ADDENDUM

ADDENDUM NO.: **01**

PROJECT NAME: **Lake View High School Renovation Project**

DATE OF ISSUE: **April 19, 2017**

1 BASEMENT FLOOR MECHANICAL REFERENCE PLAN-NORTH
1/16"=1'-0"

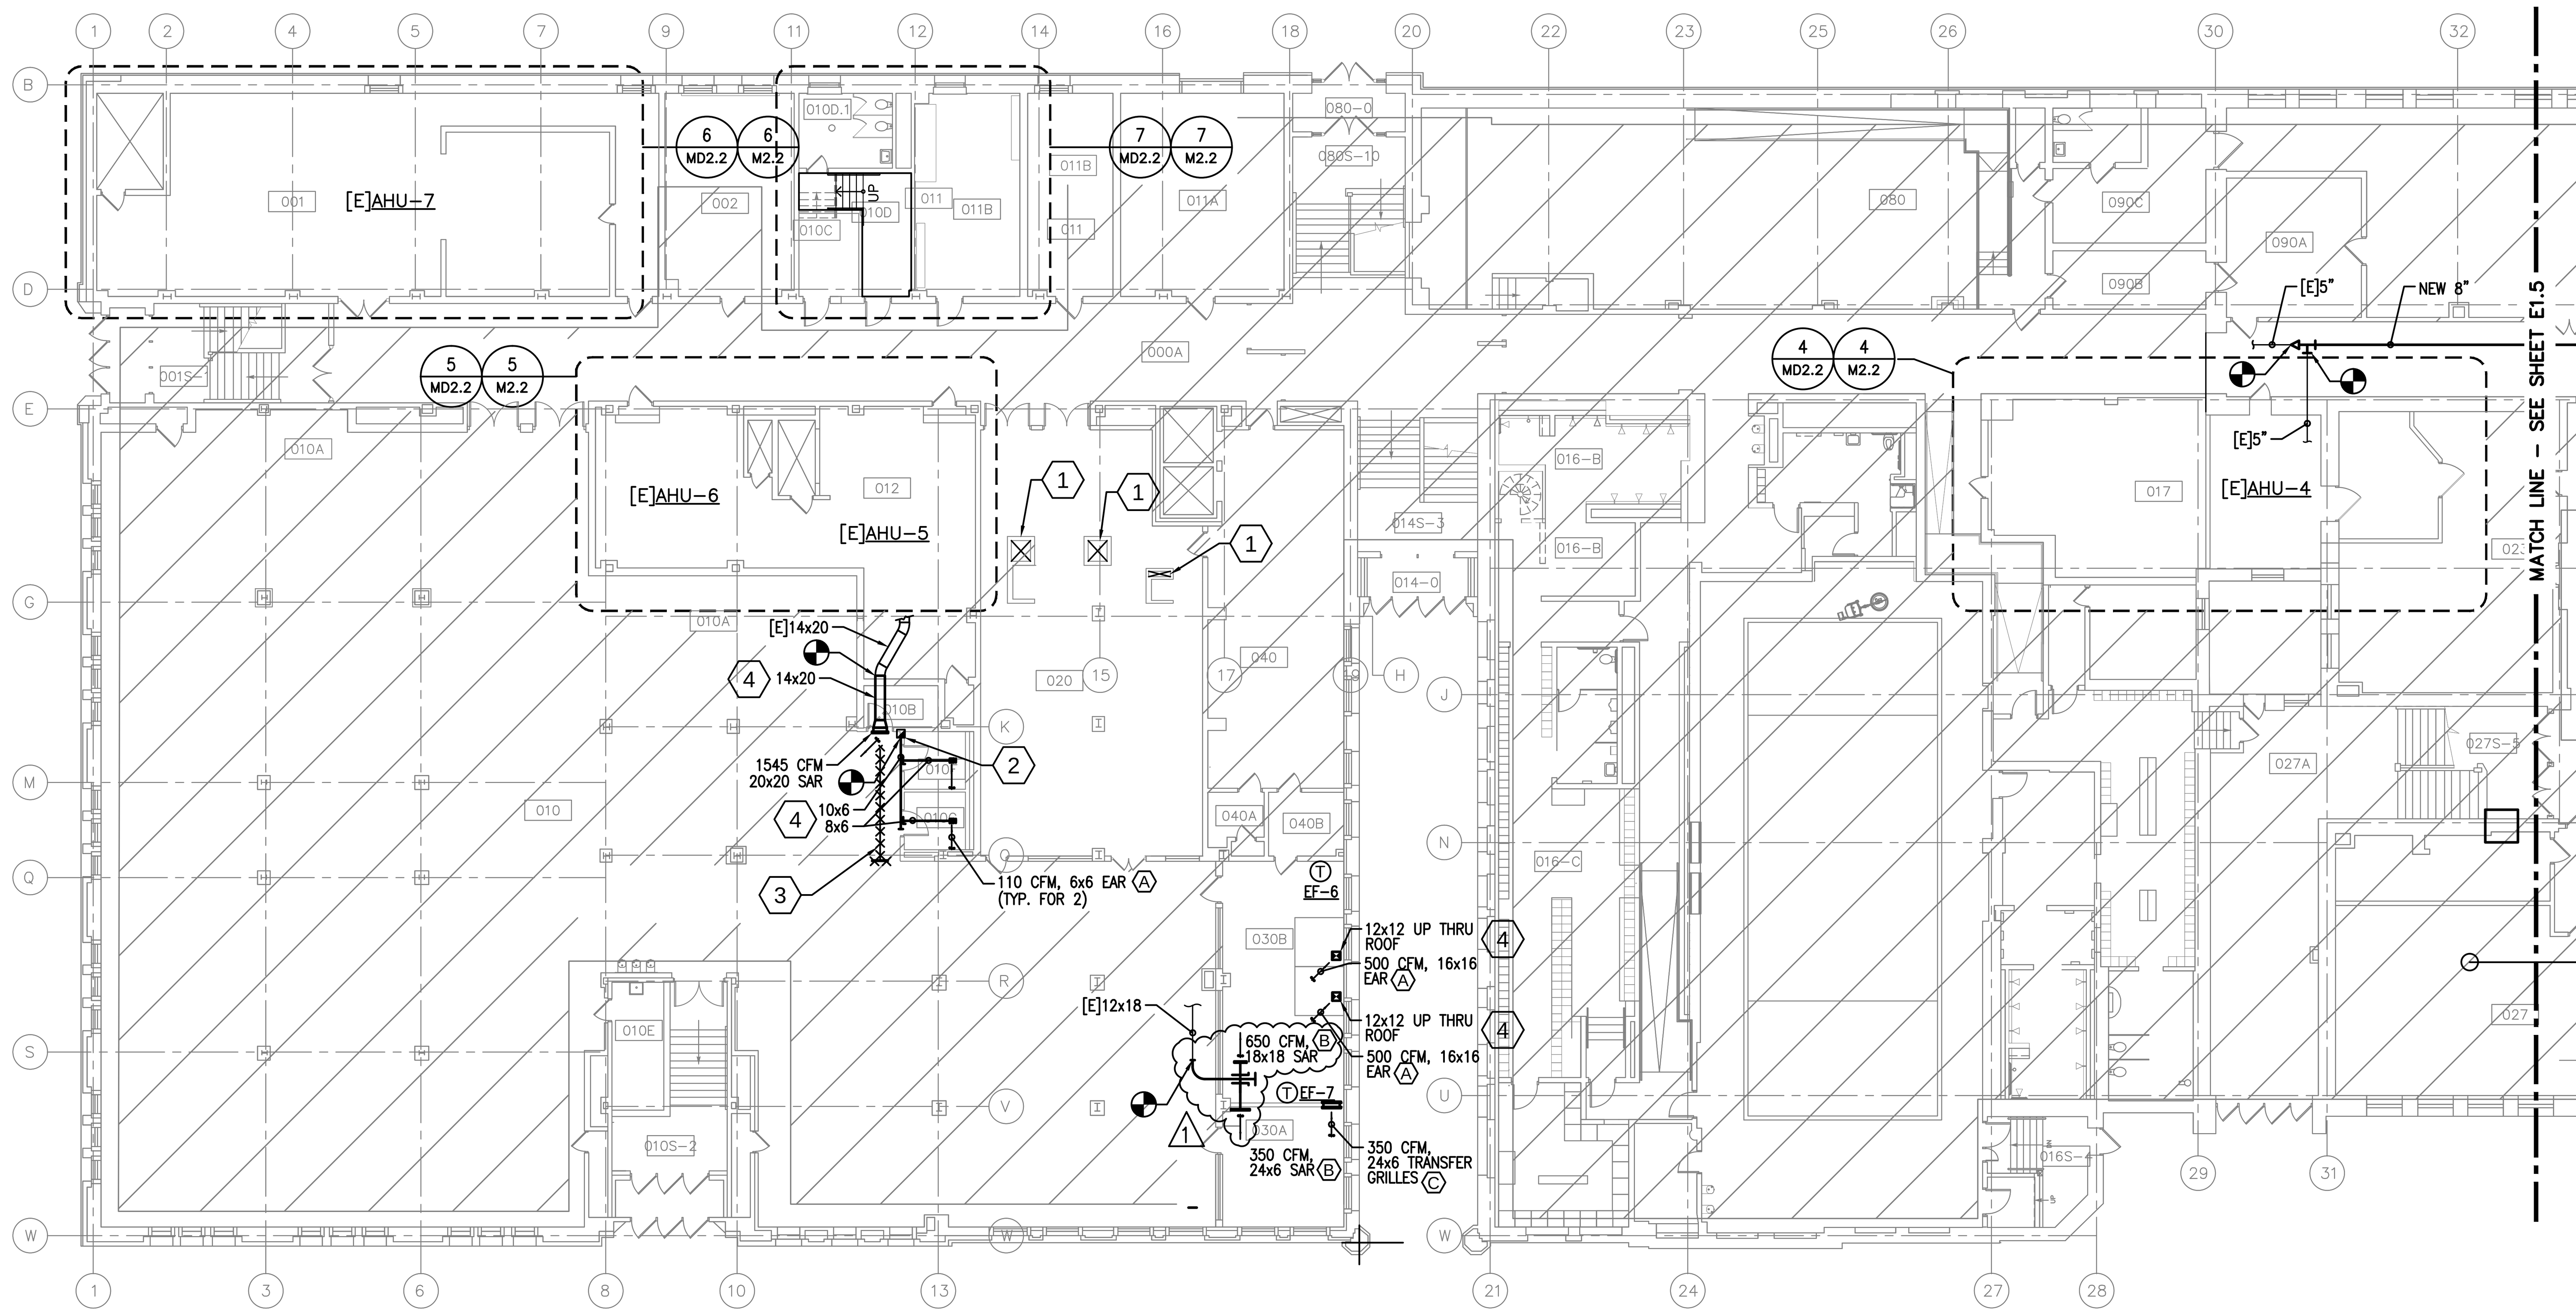
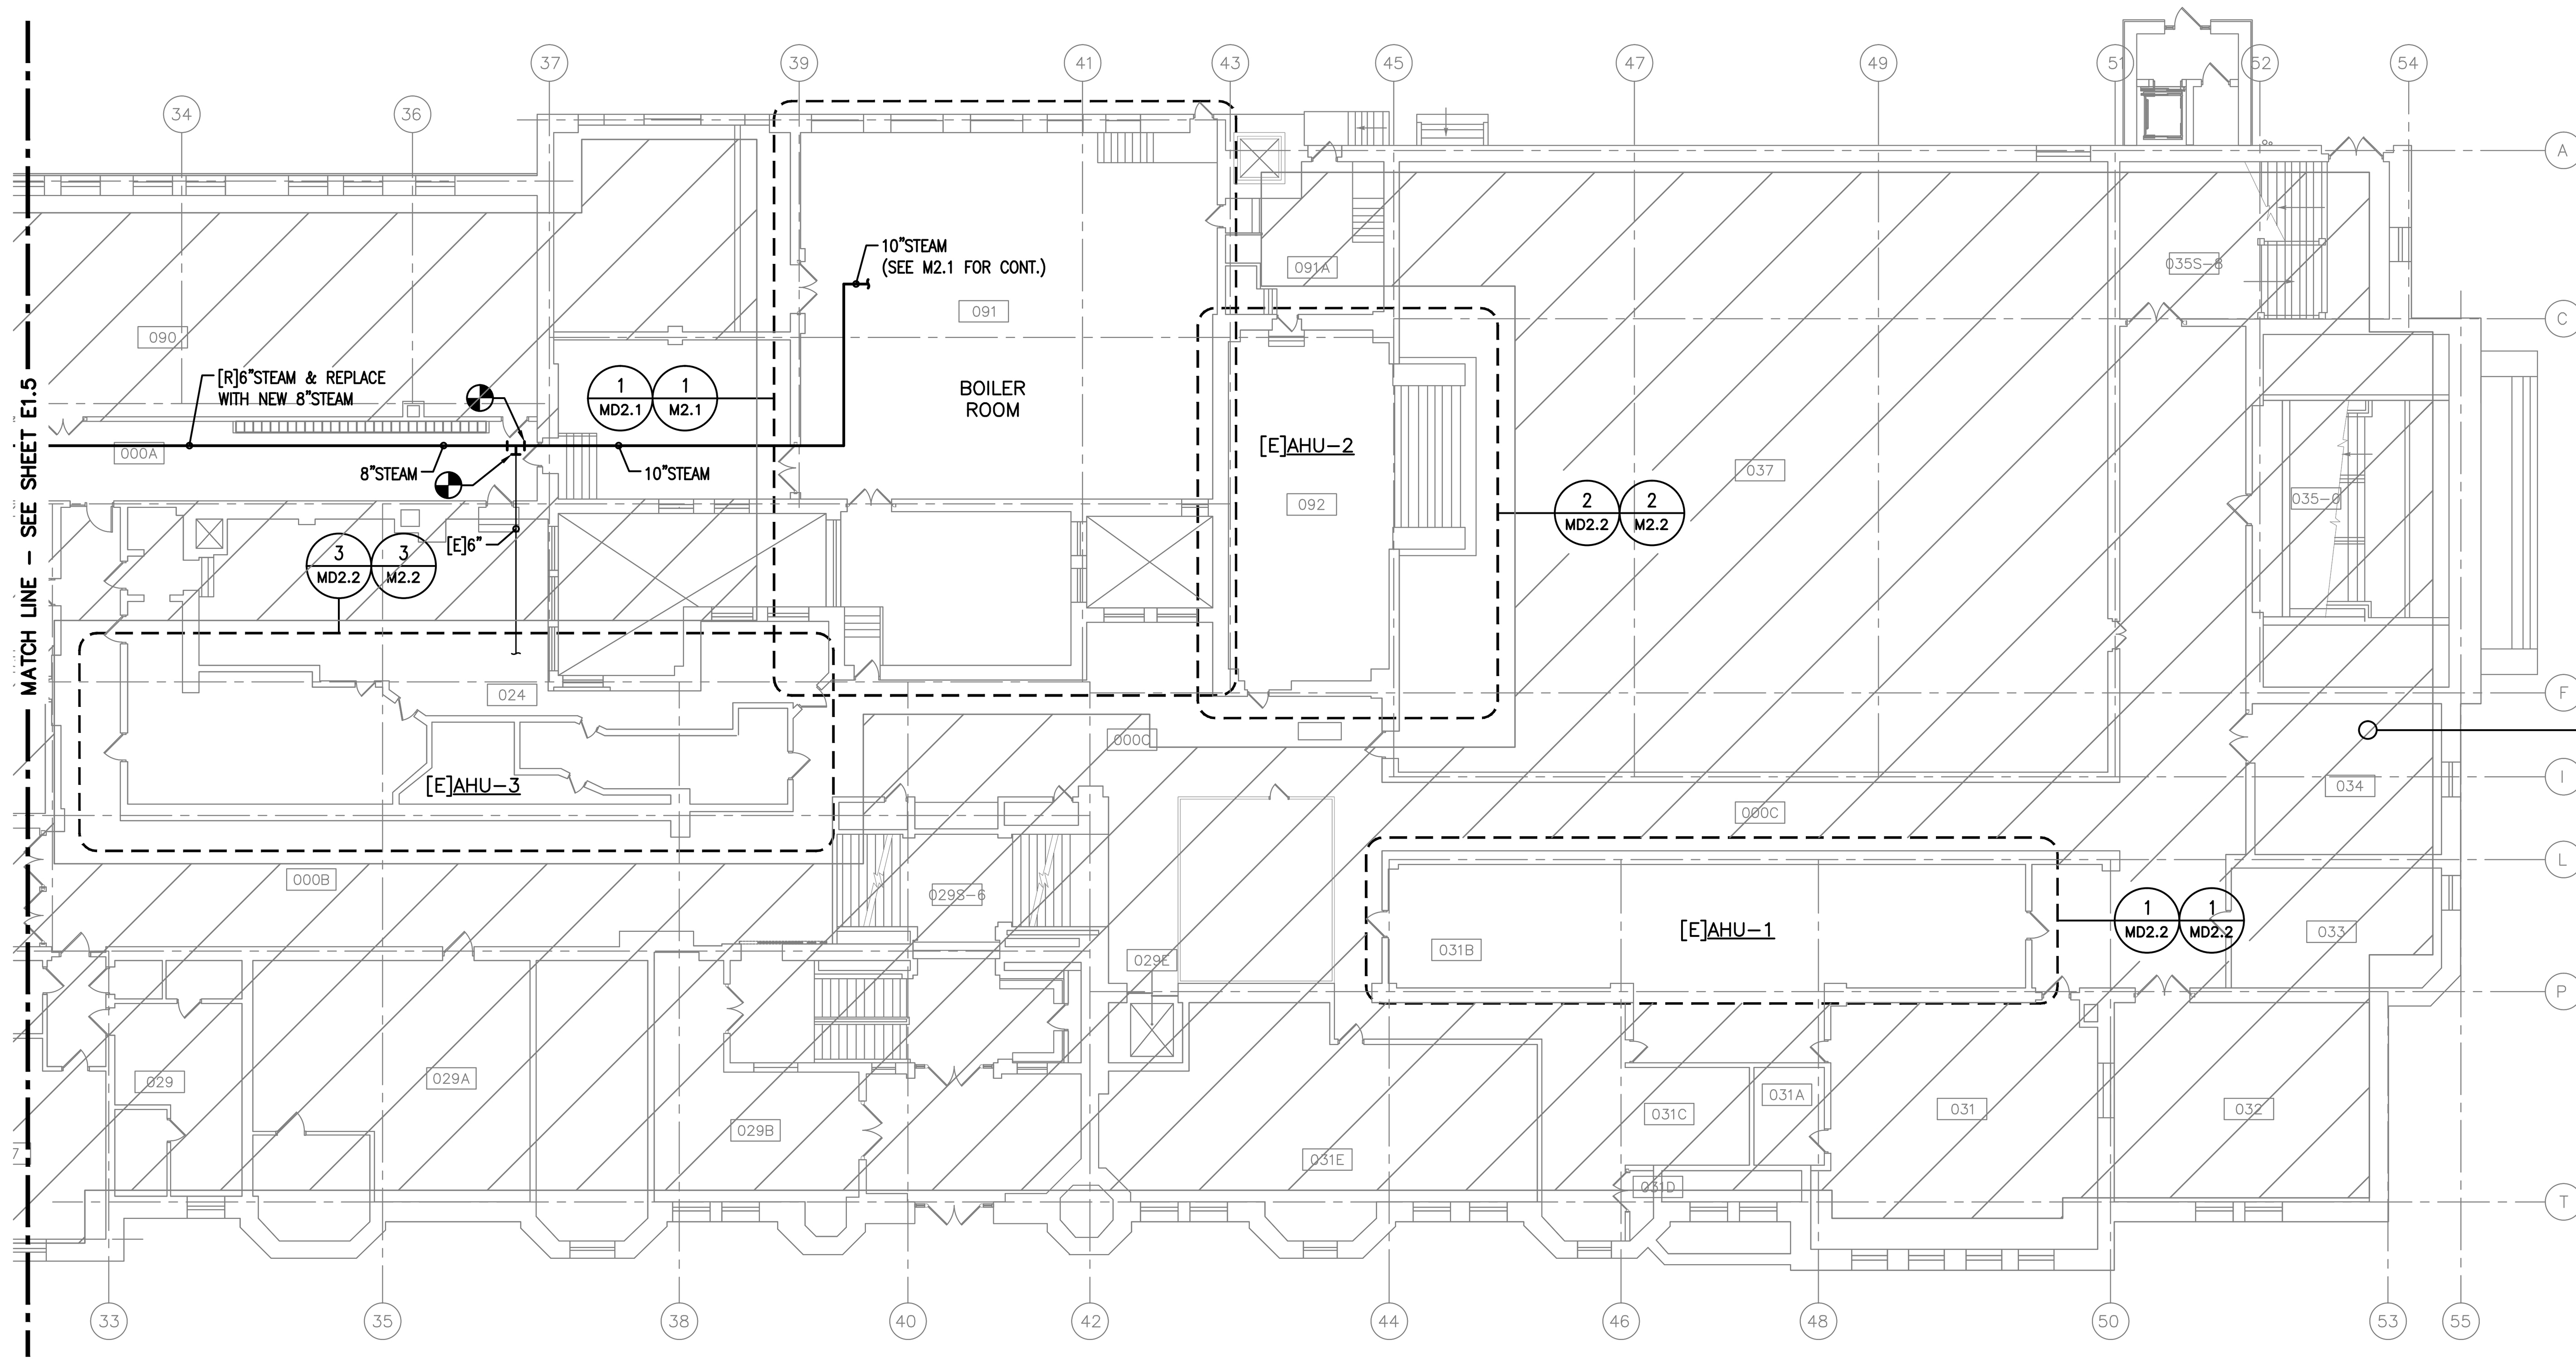
m. **REVISED** Drawing No. M1.0, BASEMENT MECHANICAL REFERENCE PLAN: Changed duct run to Rooms 030A & 030B.
n. **REVISED** Drawing No. M1.2, SECOND FLOOR MECHANICAL REFERENCE PLAN: Changed ductwork in Room 200F from rectangular to round.
